HISTORIC AND DESIGN REVIEW COMMISSION

August 21, 2019

HDRC CASE NO: 2019-465
ADDRESS: 227 GREENLAWN
LEGAL DESCRIPTION: NCB 8417 BLK 2 LOT 45
ZONING: R-5, H
CITY COUNCIL DIST.: 1
APPLICANT: ROJAS JAIME ISRAEL TREJO
OWNER: ROJAS JAIME ISRAEL TREJO
TYPE OF WORK: Installation of a 2nd driveway, accessory structure, and rear addition
APPLICATION RECEIVED: August 05, 2019
60-DAY REVIEW: October 04, 2019
CASE MANAGER: Huy Pham

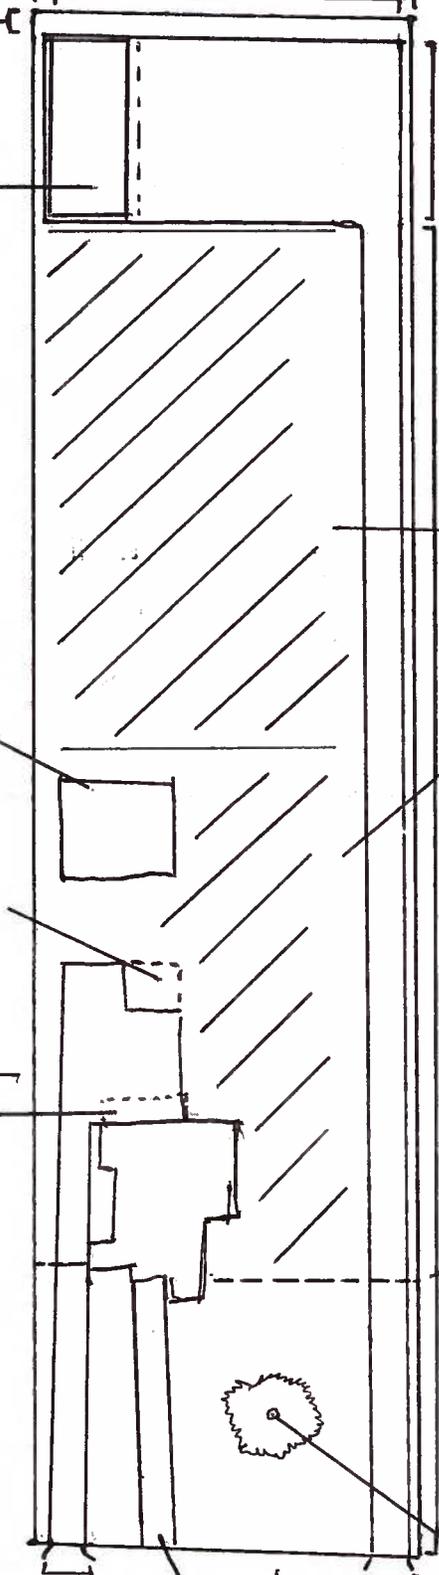
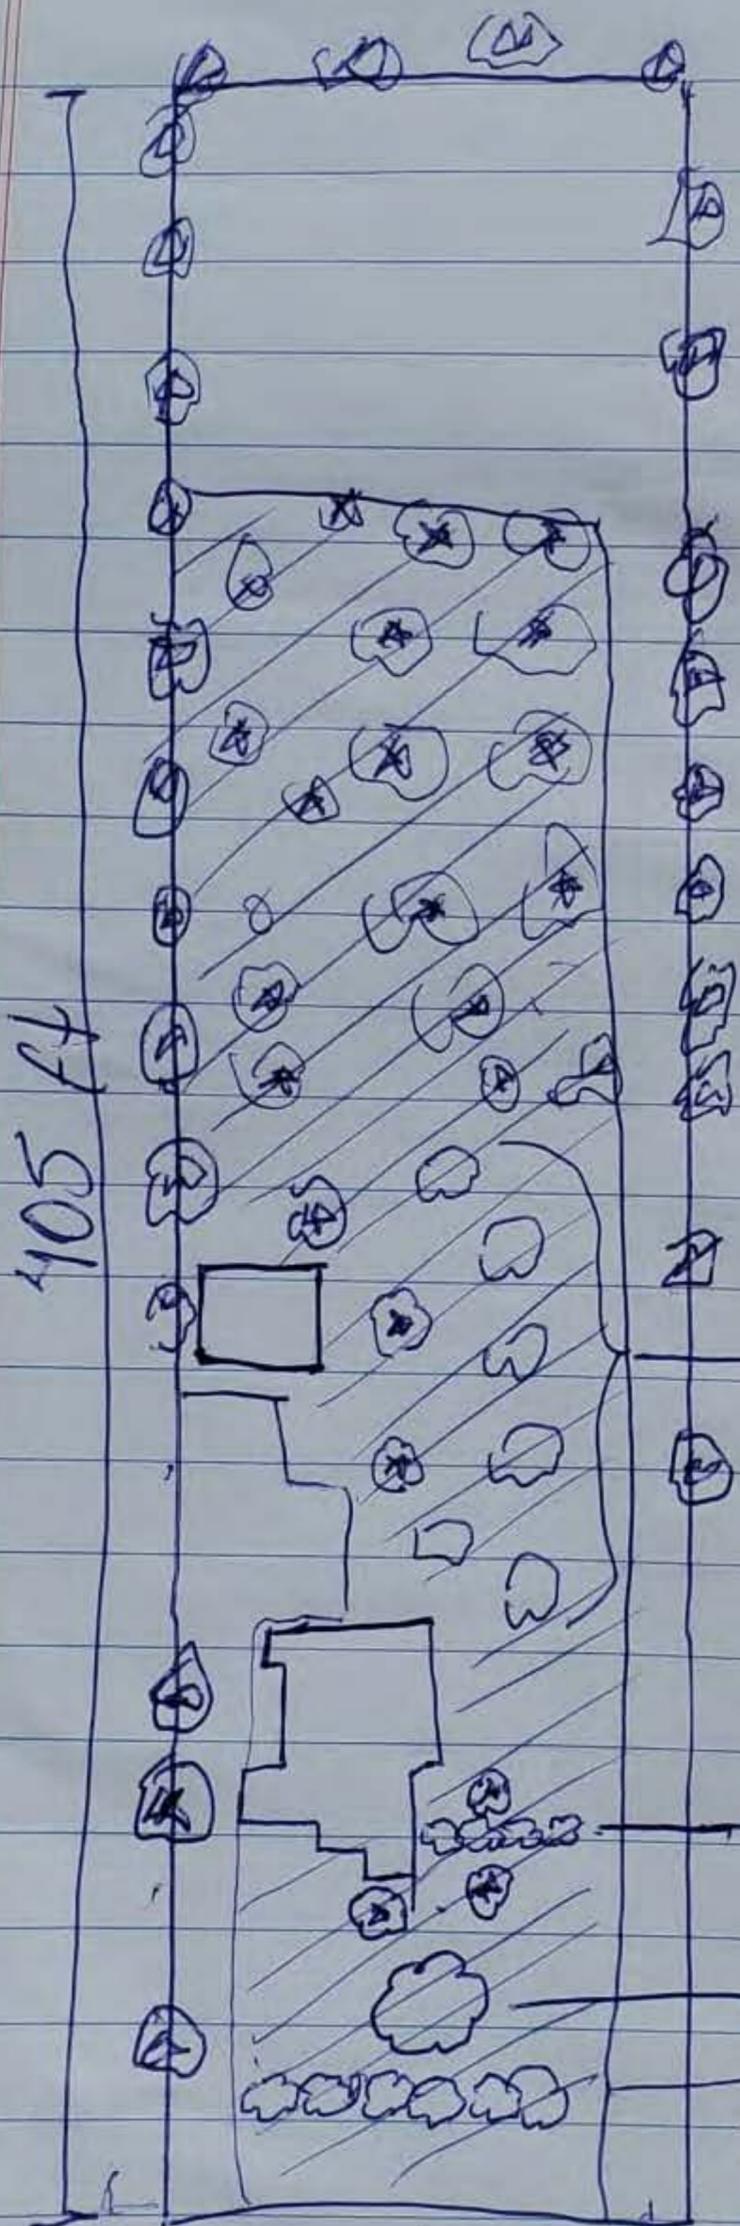
- d. **WALKWAY** – The applicant has proposed to install a center walkway featuring poured concrete that is four-feet (4') in width. Per the Guidelines for Site Elements 5.A.iii., new walkways should follow the historic alignment, configuration, and width of sidewalks and walkways found historically within the district. The property featured a non-original curving stone walkway from 2014 to 2019. Staff finds that straight and centered poured concrete walkways are found in the district and is appropriate. The width of the walkway should be limited to 3 feet or match the pattern of sidewalks in the historic district.

- e. **SECOND DRIVEWAY** – The applicant has proposed to install a secondary twelve-foot (12') driveway along the east-side of the property with a three-foot (3') setback from the neighboring fence line. The driveway would span 335' before meeting the proposed parking pad. The property currently features a 10' wide driveway on the west-side of the property leading the immediate rear yard of the primary historic structure. Per the Guidelines for Site Elements 5.B.ii., introducing new curb cuts where not historically found should be avoided. While additional driveways or curb cuts are atypical of historic structures, a number of properties in Greenlawn feature two curb cuts including 290, 244, 233, 214, 202 166, 162, 127, and 126 Greenlawn. Per the Guidelines 5.B.i 5.new driveways should feature a similar driveway configuration—materials, width, and design—to that historically found on the site. Historic driveways are typically no wider than 10 feet; pervious paving surfaces may be considered where replacement is necessary to increase storm water infiltration. Staff finds that the width of the driveway should be limited to 10 feet instead of 12 feet as proposed.

- f. **PARKING PAD** – The applicant has proposed to install a 90' by 60' parking pad at the furthest rear of the property at the end of the proposed driveway with a 10' west-side set back, a 3' east-side setback, and 5' rear setback. The parking pad would provide 5400 square feet of impervious cover. The lot currently features 42,525 square feet in size. Additionally, the parking pad would be separated from the front half of the lot including the primary historic by approximately 11,000 square feet of existing and planned tree canopy. While an atypical feature to the block, staff finds that the proposed parking pad would be minimally visibly by being set by approximately 335' and screened by tree canopies and a privacy fence.

- ii. That the width of the front walkway is limited to 3' or match pattern of sidewalks in the historic district.
- iii. That the new east-side driveway features a width of 10' instead of the proposed 12'

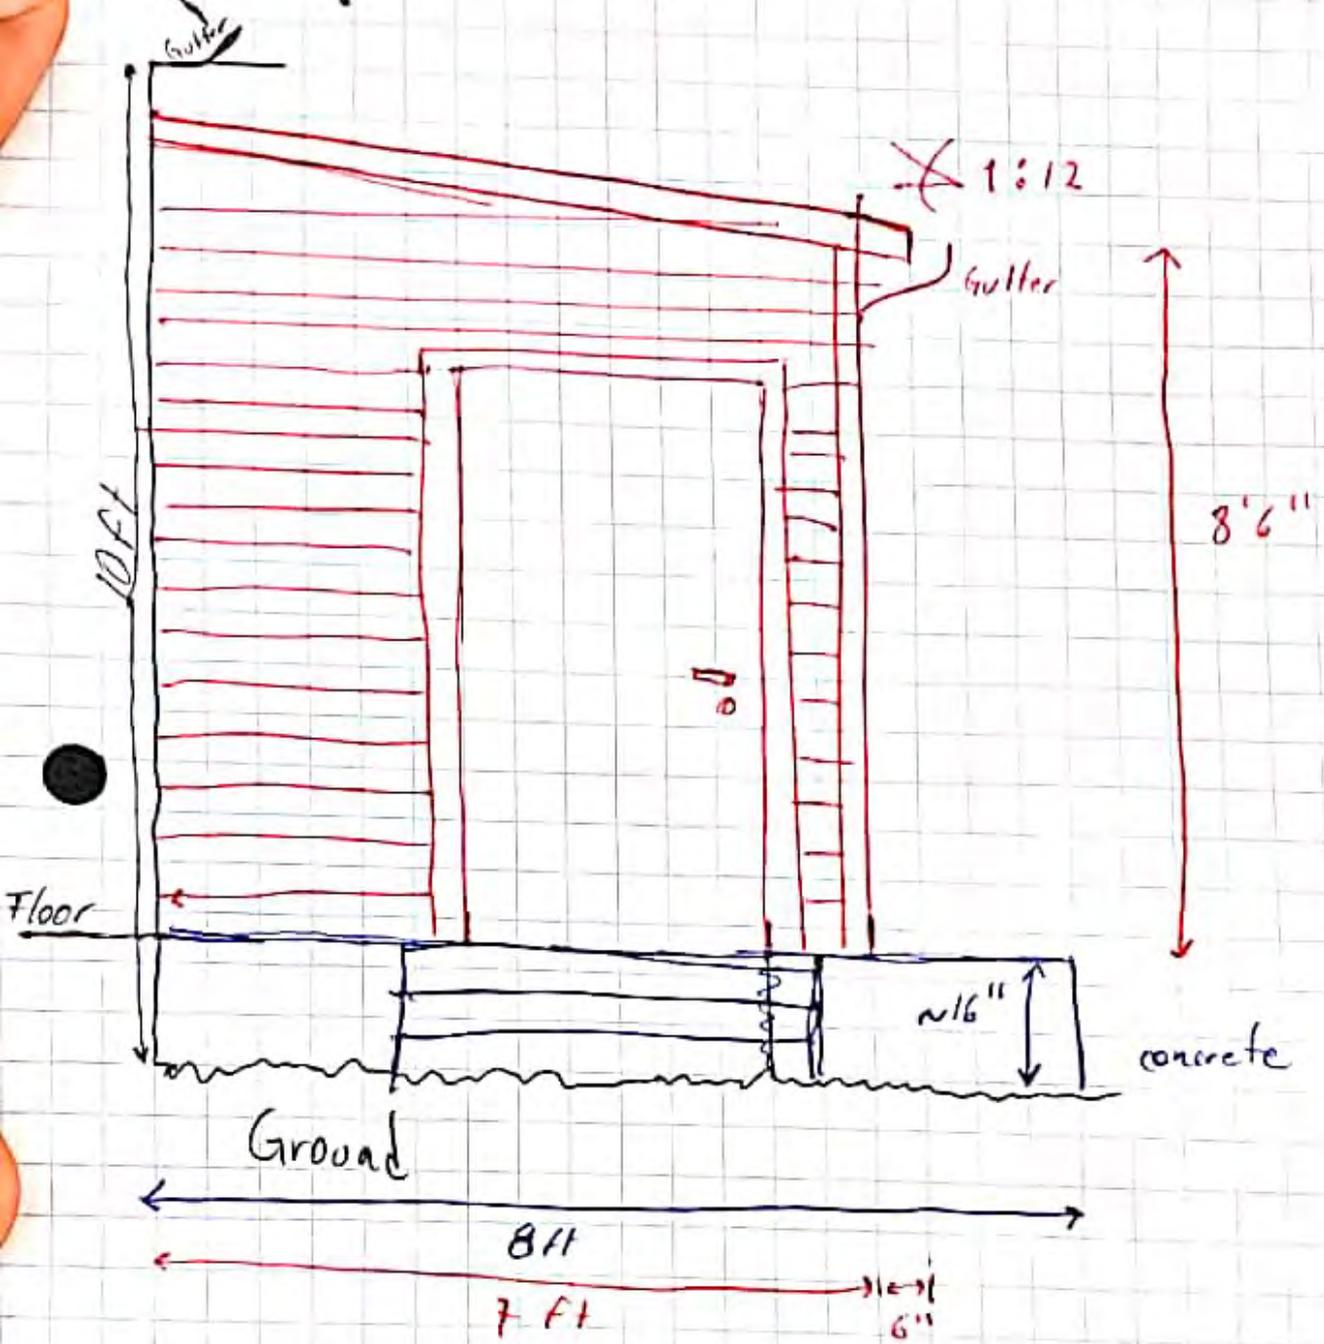
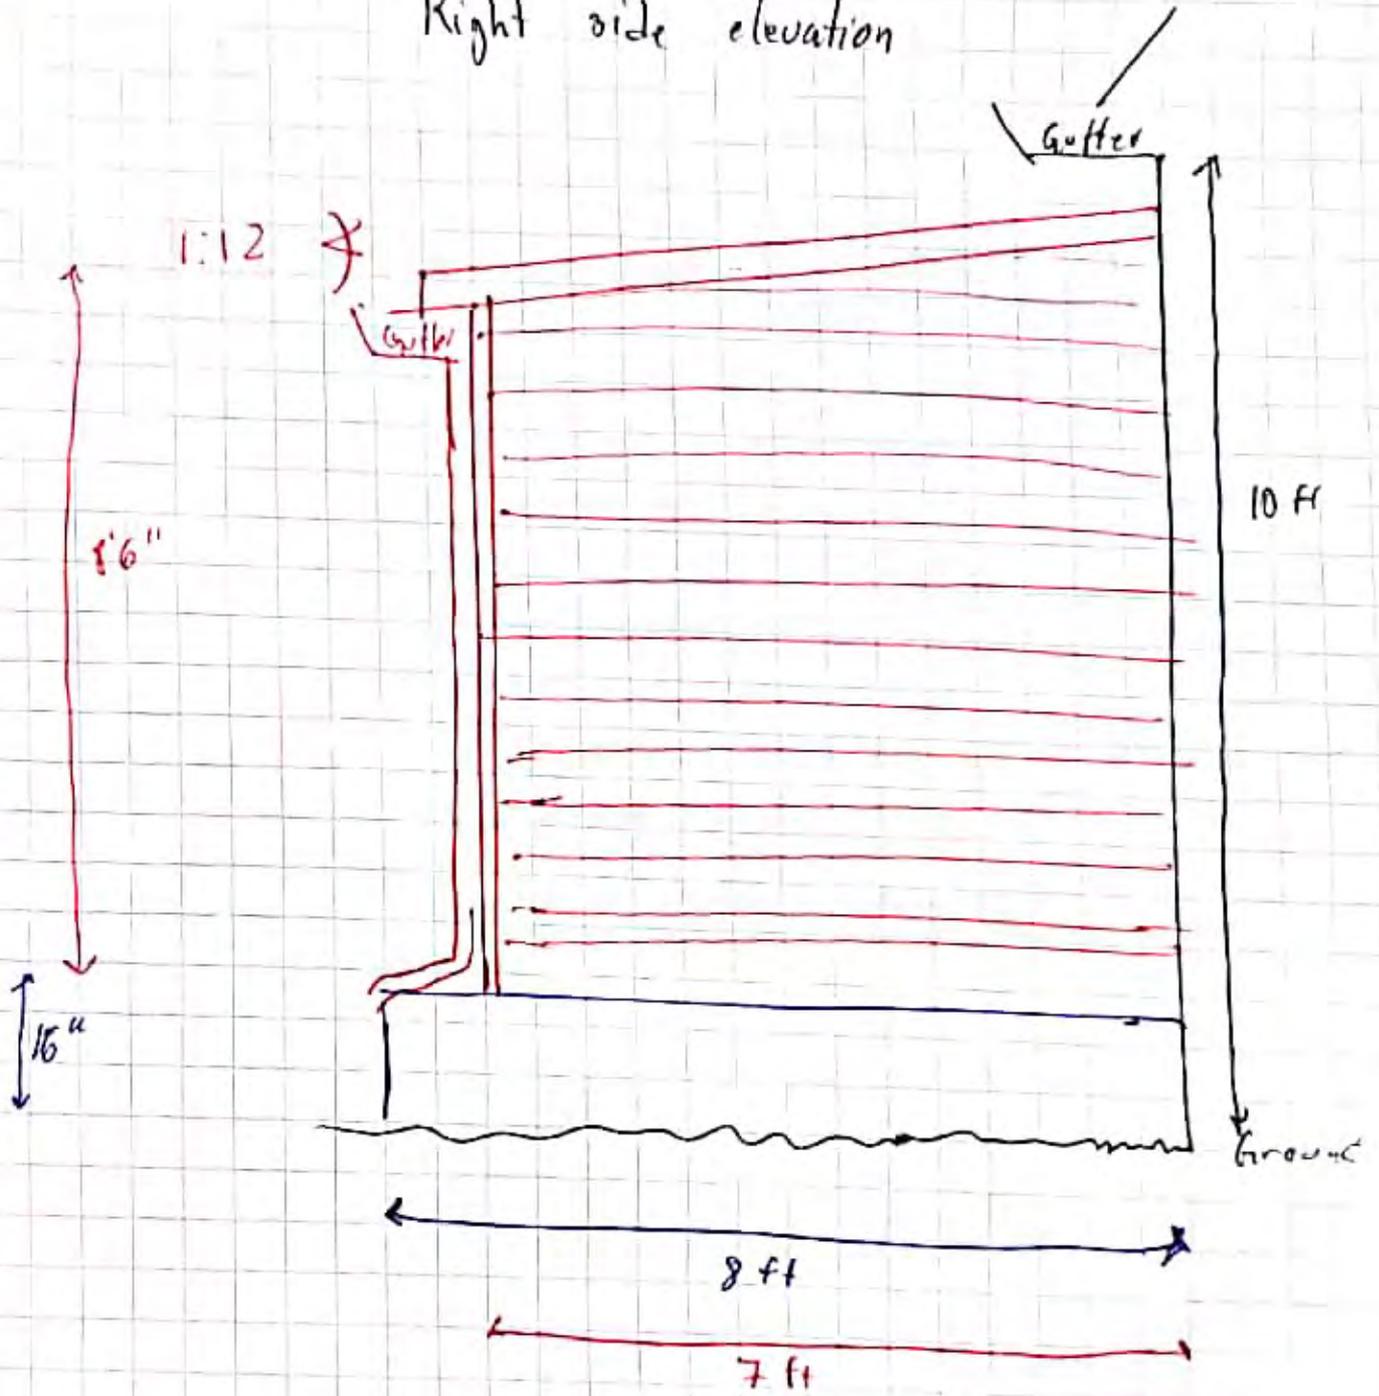
- c. **REAR ADDITION** – The applicant has proposed to install 7' by 15' rear addition for utilities on top of a new 9' by 18' concrete slab where the condenser will be placed. The proposed addition will feature Hardie lap siding, a composition shed roof, a rear facing horizontal window, and siding facing door. Staff finds that the proposed addition is consistent with the Guidelines for Additions in scale, massing, and roof form. However, staff finds that stucco siding would be more appropriate for a historic stone house than Hardie lap siding, that the rear window should match in size and configuration to windows on the existing structure, and that a design of the door should be specified and appropriate.

- i. That the rear addition features an appropriate door style, stucco siding instead of wood lap siding, and window(s) matching the existing structure in size and configuration and meet the standard stipulations: *Meeting rails that are no taller than 1.25" and stiles no wider than 2.25". White manufacturer's color is not allowed, and color selection must be presented to staff. There should be a minimum of two inches in depth between the front face of the window trim and the front face of the top window sash. This must be accomplished by recessing the window sufficiently within the opening or with the installation of additional window trim to add thickness. Window trim must feature traditional dimensions and an architecturally appropriate sill detail. Window track components must be painted to match the window trim or concealed by a wood window screen set within the opening.*

Metal storage/Garage

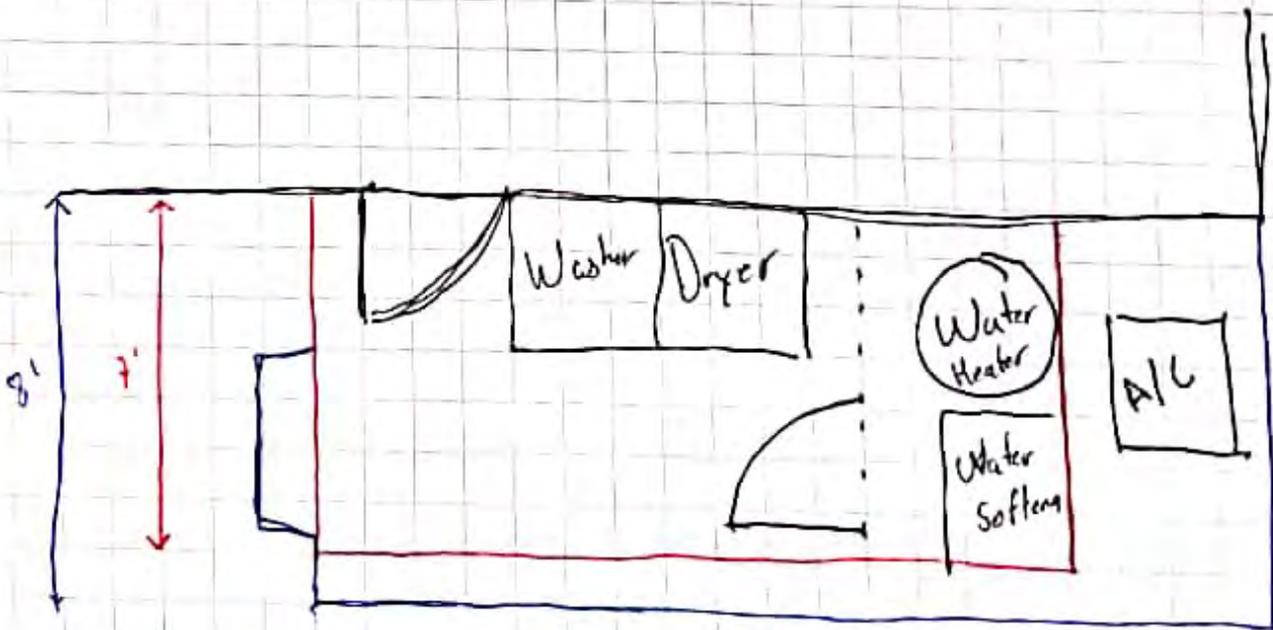
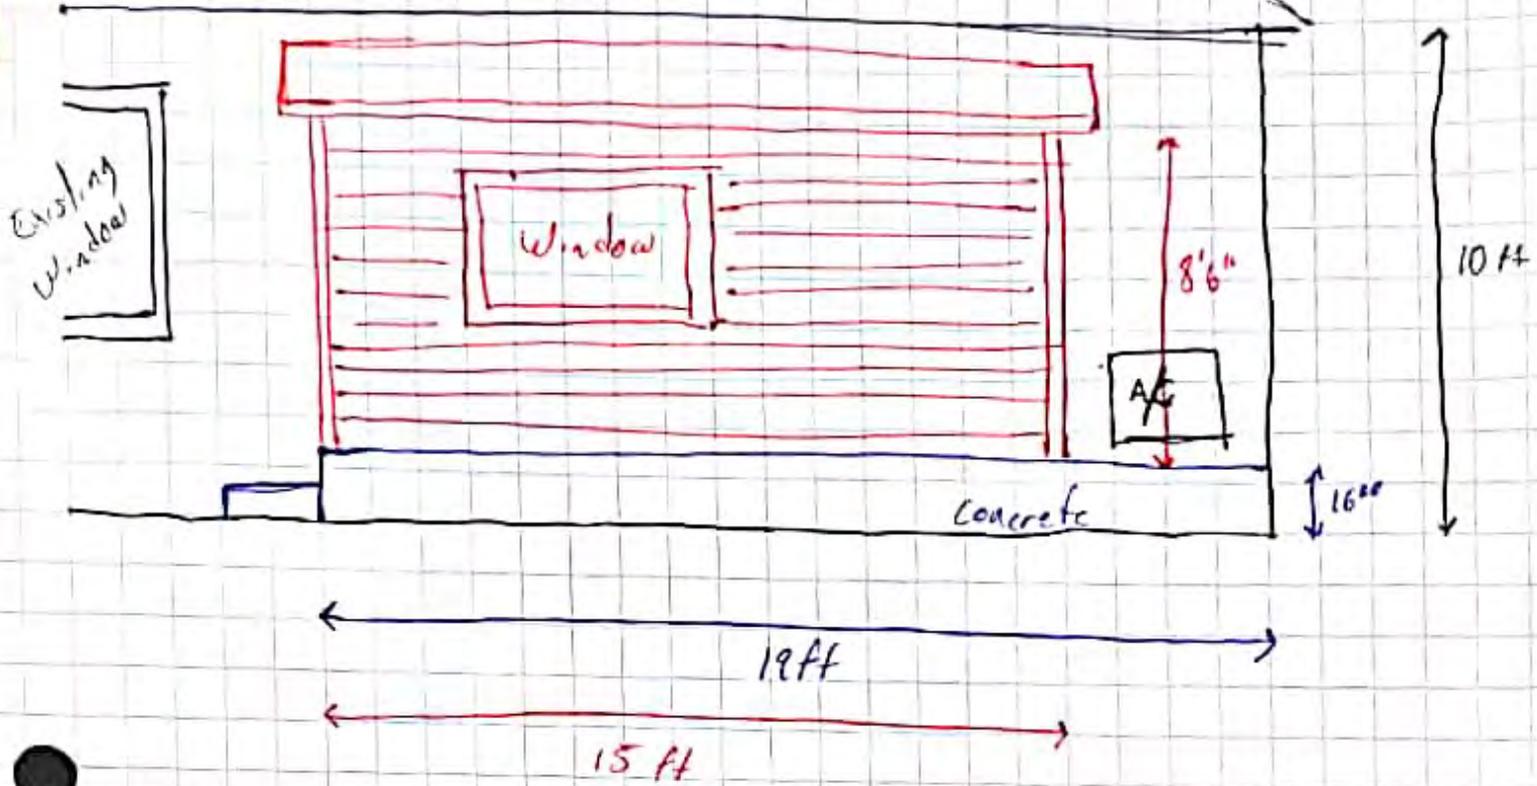
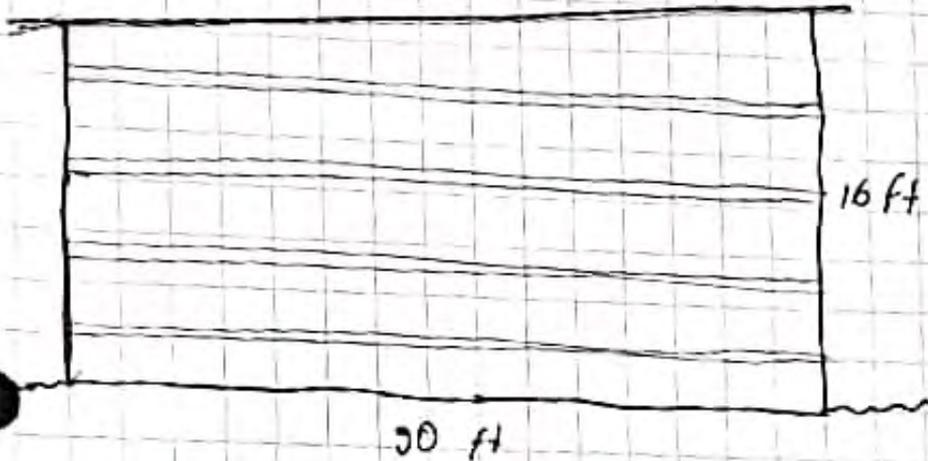
- g. **REAR ACCESSORY STRUCTURE** – The applicant has proposed to install rear accessory structure on the proposed parking pad featuring a shed metal roof, metal siding, two vehicle bays and two pedestrian door ways that is 60' in width and 30' in depth. The proposed accessory structure will be located on the west side of the property line with 10' set back from the neighboring fence line, following the orientation of the primary and existing assessor structure. Per the Guidelines for New Construction: Garages and Outbuildings, staff finds that the proposed massing, location, and orientation is generally appropriate. However, staff finds that the materials and roof form should instead feature wood or Hardie board-and-batten and a simple gable roof to relate to the existing accessory structure on the property.

- iv. That the new rear accessory structure feature wood or Hardie board-and-batten siding and a gable roof instead of the proposed shed roof.
- v. That updated measured drawings and site plan with specifications for the rear addition, rear accessory structure featuring appropriate details are provided to staff prior to purchase and installation.
